CITY OF WEST TORRENS

Notice of Panel Meeting

**TUESDAY, 11 MAY 2021
at 5.00pm**

DESCRIPTION OF DEVELOPMENT	Demolition of existing buildings (nine in total), retention of existing Local Heritage Place and construction of new buildings and refurbishment of existing buildings for an integrated mixed use development comprising a restaurant and bar, microbrewery, commercial warehouses and service industries with associated car parking, boundary fencing and landscaping - (Non-Complying)
APPLICANT	L Meyer C/- Ekistics Planning and Design
APPLICATION NUMBER	211/702/2020
LODGEMENT DATE	11 August 2020
ZONE	Commercial Zone Residential Zone
POLICY AREA	District Commercial Policy Area 2 Low Density Policy Area 20
APPLICATION TYPE	Non-Complying
PUBLIC NOTIFICATION	Category 3
REFERRALS	Internal <ul style="list-style-type: none"> City Assets Waste Management Heritage Advisor External <ul style="list-style-type: none"> Department of Infrastructure and Transport (DIT)
DEVELOPMENT PLAN VERSION	Consolidated 21 May 2020

FLOOR PLAN - HERITAGE BUILDING A - PROPOSED
1:100

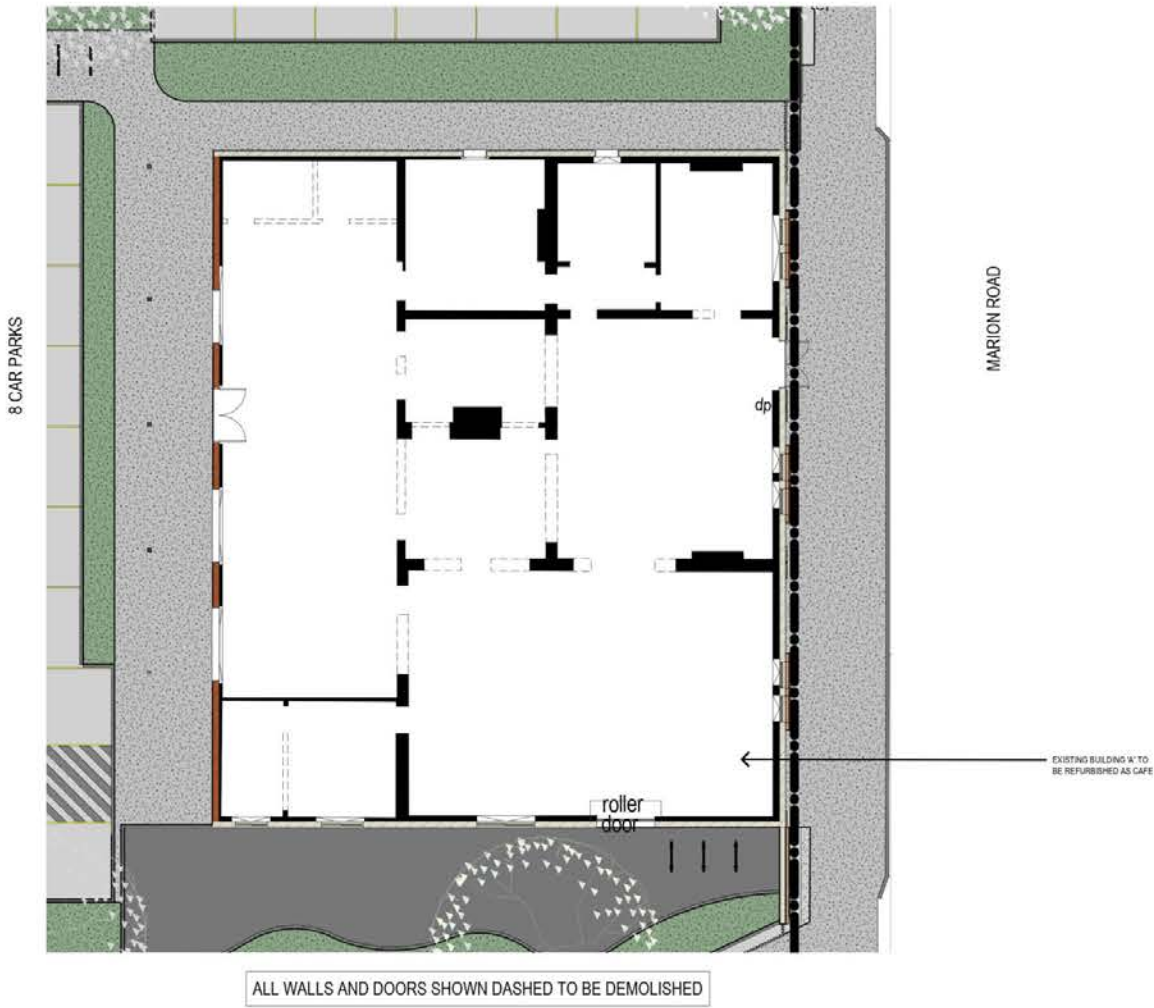
The proposal has full heritage support and it is recommended that the new 'internal' opening to the south wall should comprise a nib to each side and that the wall be evident above the opening and below the ceiling line to provide evidence of the original wall. A condition to this effect has been included within the recommendation.

17. The new internal opening to the south wall of the Local Heritage Place shall comprise a nib to each side with the wall to be evident above the opening and below the ceiling line to provide evidence of the original wall.

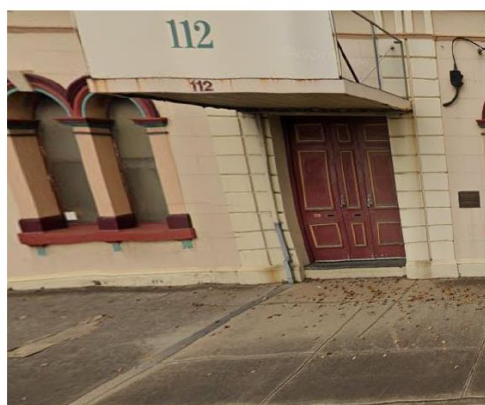
3.1 City Assets has previously commented that the northern existing crossover at Marion Road should be reinstated to vertical kerb prior to the completion of any building works at the applicant's expense and should be indicated on revised plans that any redundant crossovers will be reinstated. However, I noticed that only the architectural plan has indicated that the crossover will be reinstated, and the civil plan has leave the crossover as its current state.

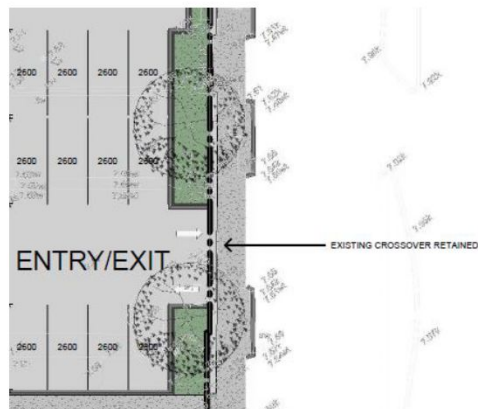
It is recommended that revised plans showing the reinstatement of redundant crossovers be provided to Council.

- 3.2** No further assessment provided. Item still considered outstanding.

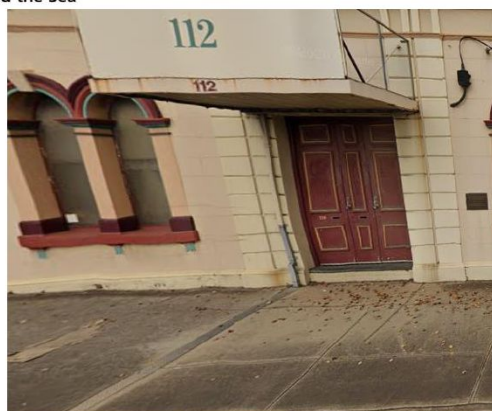
It is recommended that revised plans showing satisfaction to the above requirements be provided to Council.

- 3.3** The offsets for verge features have been assessed as acceptable in accordance with the site layout shown on 'Stormwater Plan' (Sagero, Ref: SA200018-C01&C02-E, dated 27/11/2020)
- 3.4** It should be noted that there is a rise at the entrance of the existing heritage building at South Road. As this building has been constructed to the boundary, if the applicant wishes to construct the entrance to DDA compliant, then the slope should be constructed within the building.
